Planning and Development (Plan Variation No 317) Notice 2014

Notifiable Instrument NI2014-137

Variation to the Territory Plan No 317

Kambah Group Centre –
Amendments to the
Kambah precinct map and code
and zone changes

Figure 2: Current Territory Plan provisions for Kambah group centre

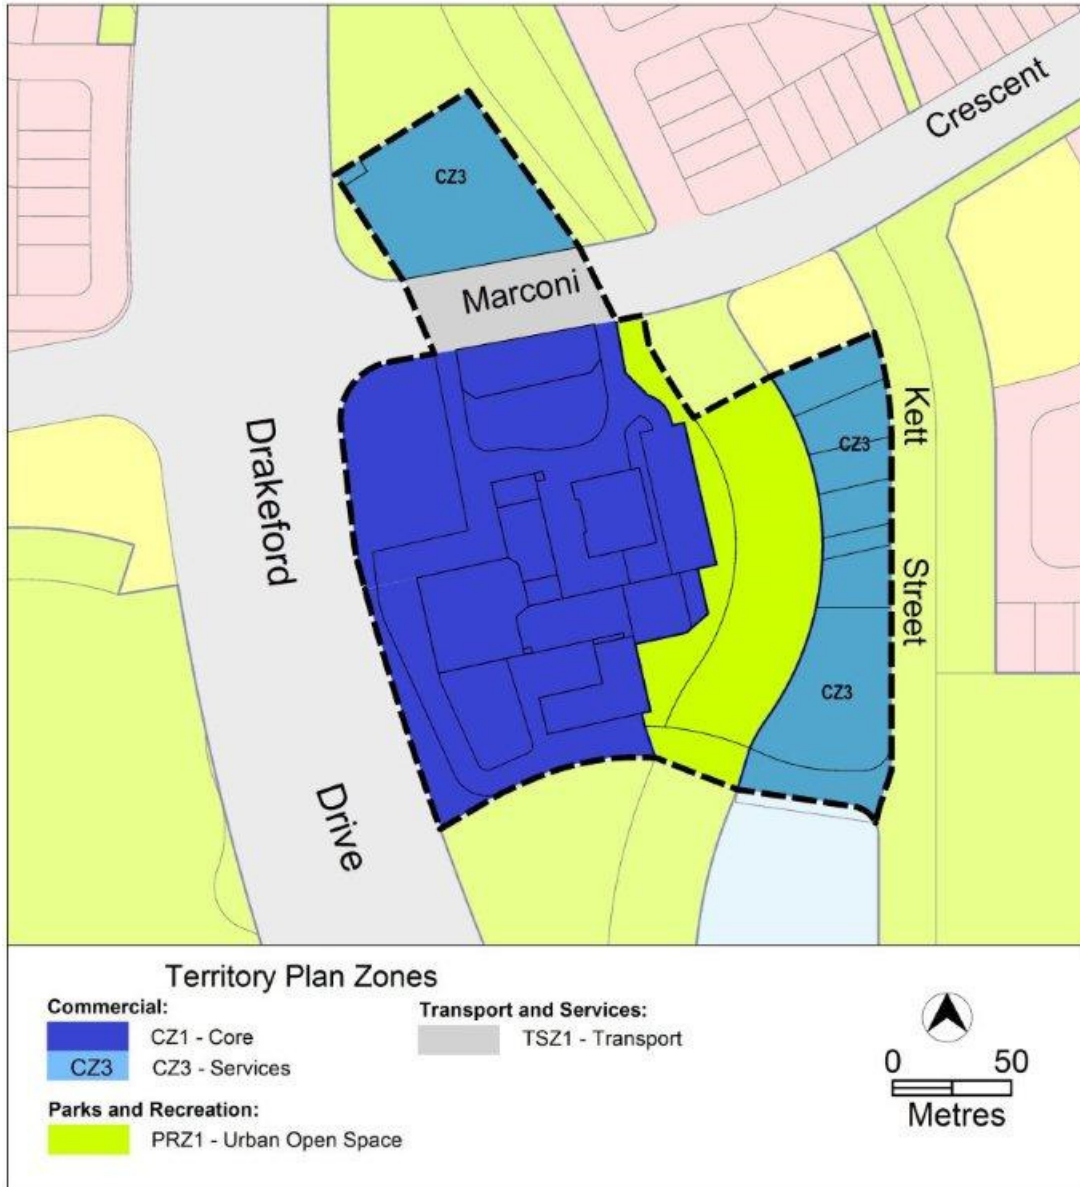
The core of the Kambah group centre is zone CZ1 – commercial core, while the service station to the north and the line of commercial blocks to the east are zoned CZ3 – services zone. The stormwater swale between the core area and the services area is zoned PRZ1 – urban open space.

Figure 3: New Territory Plan provisions for the Kambah Group Centre

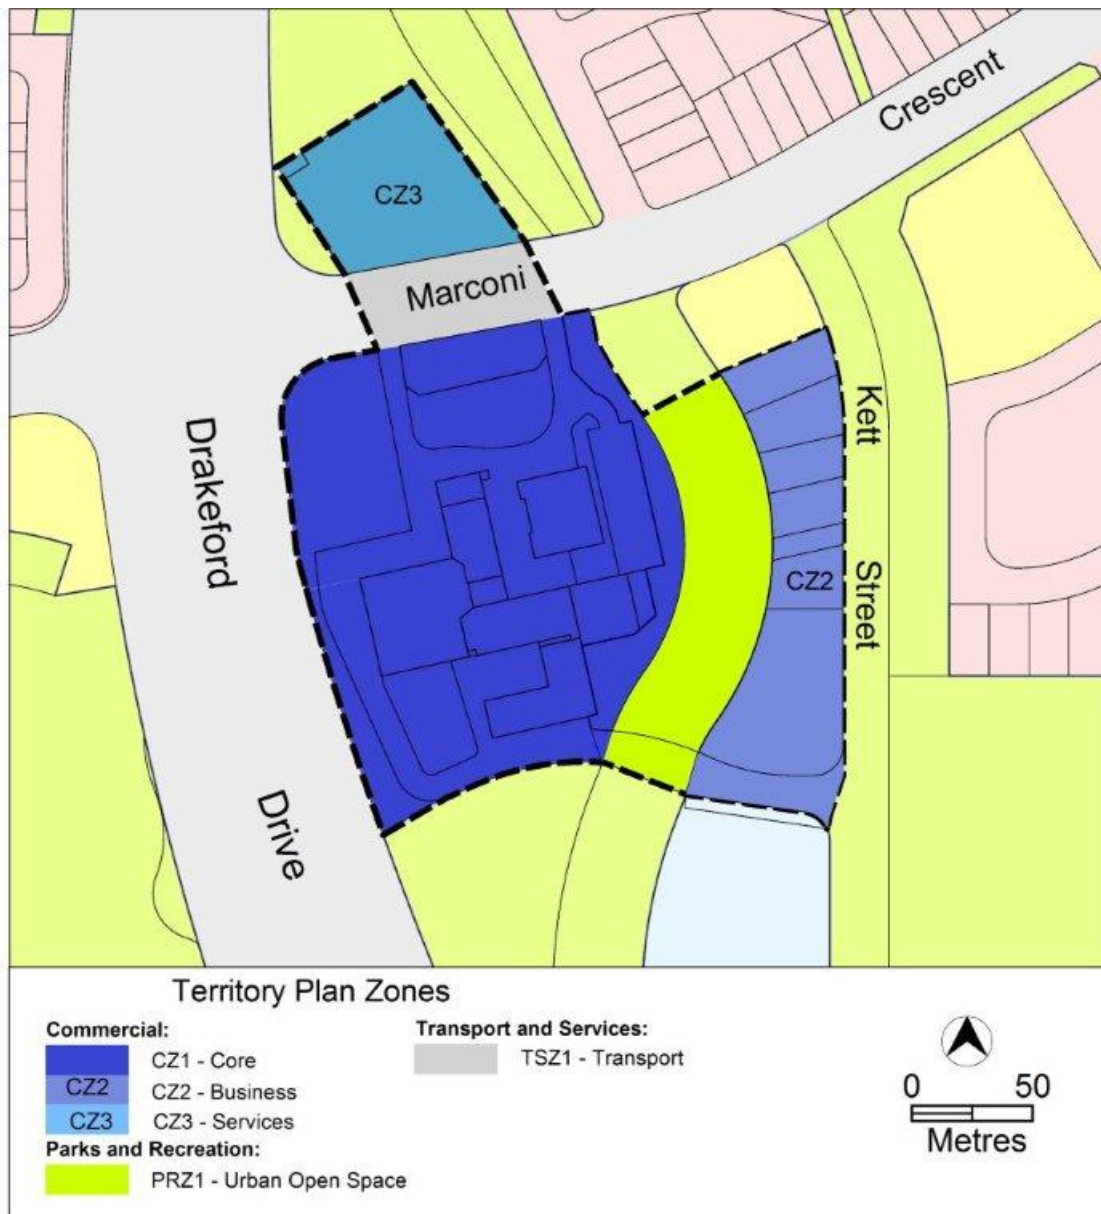
- a section of PRZ1 located between the existing CZ1 core commercial area of the Kambah group centre and the grassed stormwater swale is rezoned to CZ1 core zone
- the CZ3 services zone on the eastern side of the group centre is rezoned to CZ2 business zone

The Territory Plan map is varied as indicated in figure 3

Figure 1 Parking and permitted uses

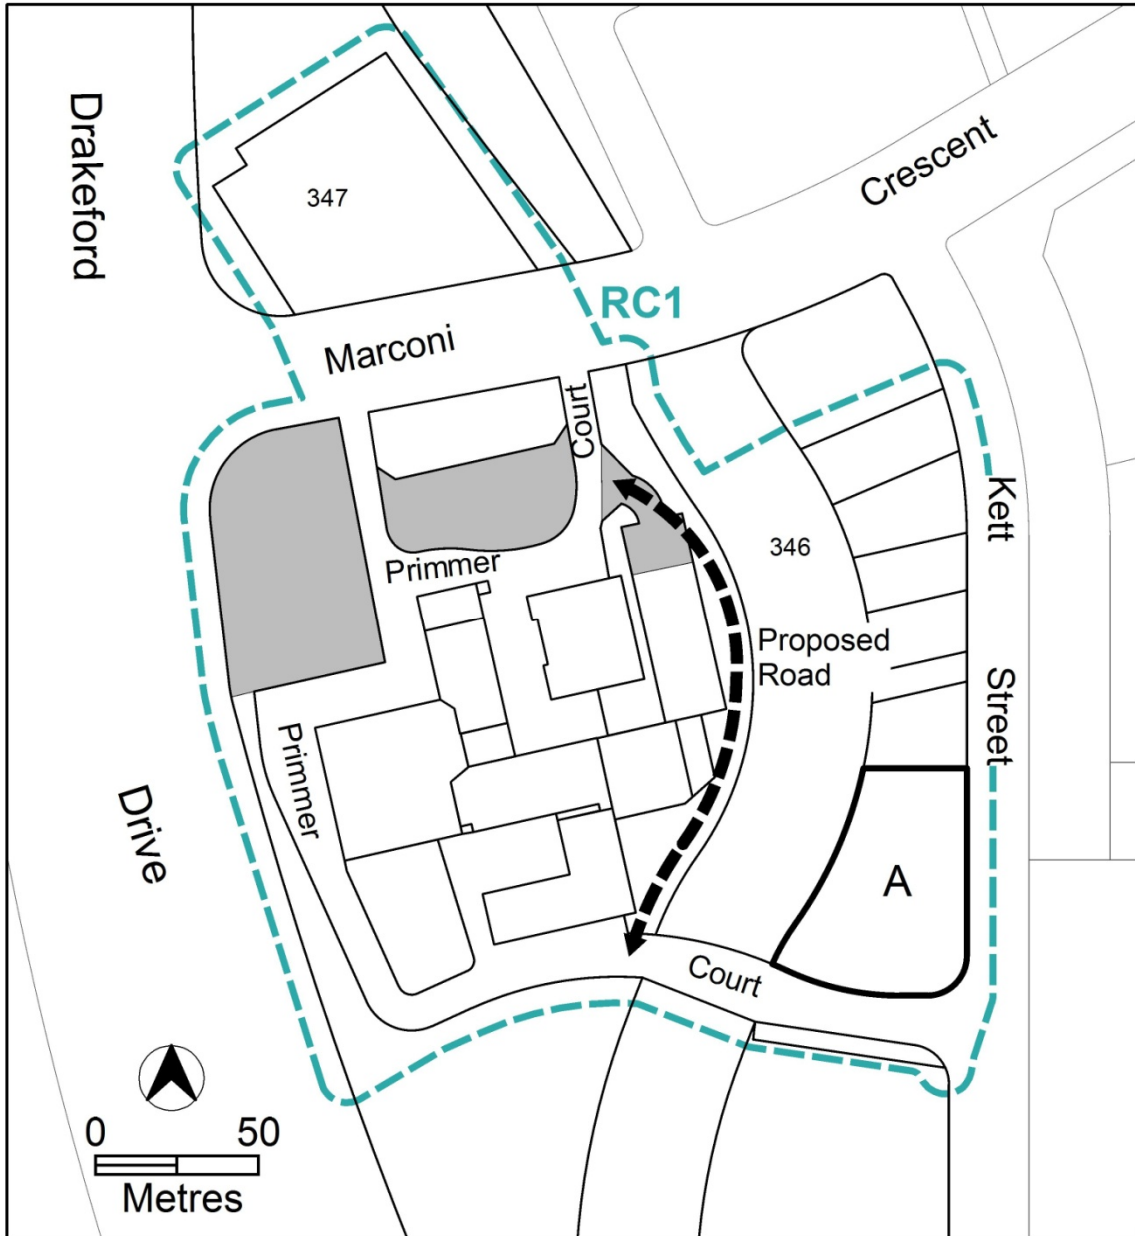
DV317 (public release version)	V317 (approved version)	Change
N/A	R7 (new rule)	Provisions to describe the design of the proposed road between the core area and the open space (stormwater swale) to the east.
Figure 1	Figure 1	Figure simplified to show nominated car parks, proposed road to the east, and area A (ex area D).
R8	Now R9	Rule amended for clarity, and refers to (new) figure 2.
R9	Now R10	No substantive change.
N/A	Figure 2 (new)	New figure to describe heights, and with a hatched area associated with rule R6.
C10	Deleted	C10 was removed as the intent of the criteria was duplicated by C11 (consultation version).
C11, C12, C13, R14, R15	C11, C12, C13, R14, R15	No substantive change.
Figure 2	Now Figure 3	Figure amended to indicate required secondary frontage as part of any future development to the north of the existing supermarket.
R16, R17, C18, R19	R16, R17, C18, R19	No substantive change.

1.4 Industrial trades, municipal depot, store	
<p>R4</p> <p>One or more of the following uses are permitted only in the shaded area shown in figure 1 and only in association with a structured <i>car park</i>:</p> <p>a) <i>industrial trades</i></p> <p>b) <i>municipal depot</i></p> <p>c) <i>store</i></p>	<p>This is a mandatory requirement. There is no applicable criterion.</p>

1.5 Development on nominated car parking areas	
<p>R5</p> <p>This rule applies to the shaded areas shown in figure 1.</p> <p>Development complies with all of the following:</p> <p>a) the existing number of car parking spaces are retained on site and made available for public use at all times</p> <p>b) provides car parking that is generated by the development on site in accordance with the <i>Parking and Vehicular Access General Code</i> in addition to the spaces required by a)</p>	<p>C5</p> <p>Development achieves all of the following:</p> <p>a) any additional parking provision requirements (under the <i>Parking and Vehicular Access General Code</i>) for the development</p> <p>b) makes a substantial contribution to the long term publicly accessible parking supply at the group centre</p>

Rules	Criteria
<p>R7</p> <p>The design of the proposed road in figure 1 complies with all of the following:</p> <ul style="list-style-type: none"> a) In a location consistent with figure 1 b) Complies with R5/C5 where relevant c) Provides on street parking d) Road design and on street car parking is to the satisfaction of TAMSD <p>Note: The Kambah group centre master plan must be considered in the assessment of the location of the proposed road and on street parking.</p>	<p>This is a mandatory requirement. There is no applicable criterion.</p>
<p>R8</p> <p>Direct vehicular access is not permitted from the proposed road shown in figure 1 to adjoining blocks.</p>	<p>This is a mandatory requirement. There is no applicable criterion.</p>

Figure 2 Heights and vehicular circulation

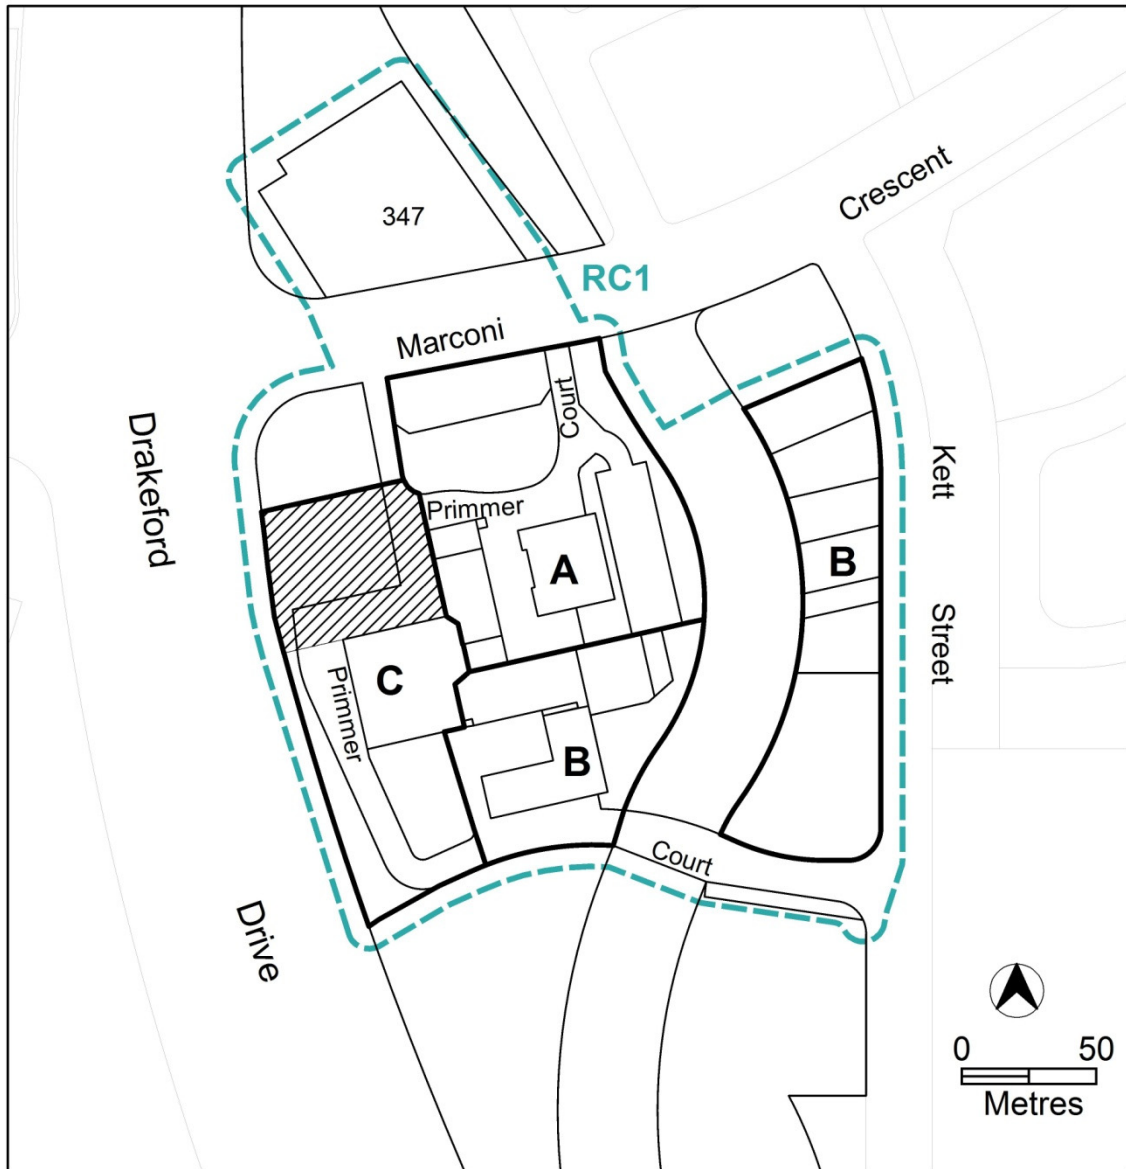
R3	Now R4	No substantive change.
R4	Now R5	Amended to the standard rule and criteria for nominated car parks.
R5	Deleted	Not required. Other provisions have been included in the code regarding the proposed road to the east of the core area.
R6	R6	No substantive change to the rule, though it now refers to a new figure which was added for clarity.
R7	Now R8	Wording amended for clarity.

1.6 Vehicular circulation and access	
<p>R6</p> <p>Development of all or a portion of the hatched area identified in figure 2 maintains Primmer Court vehicular access around the western side of the centre.</p>	<p>This is a mandatory requirement. There is no applicable criterion.</p>

Rules	Criteria
2.1 Heights	
<p>R9</p> <p>This rule applies to areas identified in figure 2. The maximum height of building is as follows:</p> <ul style="list-style-type: none"> a) in area 'A' – 16m b) in area 'B' – 12m c) in area 'C' – 9m <p>Building height measurement excludes all of the following:</p> <ul style="list-style-type: none"> a) roofs with a pitch not more than 36° b) roof top plant c) lift overruns d) antennas e) photovoltaic panels f) air conditioning units g) chimneys, flues and vents <p>The minimum setback of excluded items b) to g) from the building facade of the floor immediately below is 3m.</p>	<p>This is a mandatory requirement. There is no applicable criterion.</p>
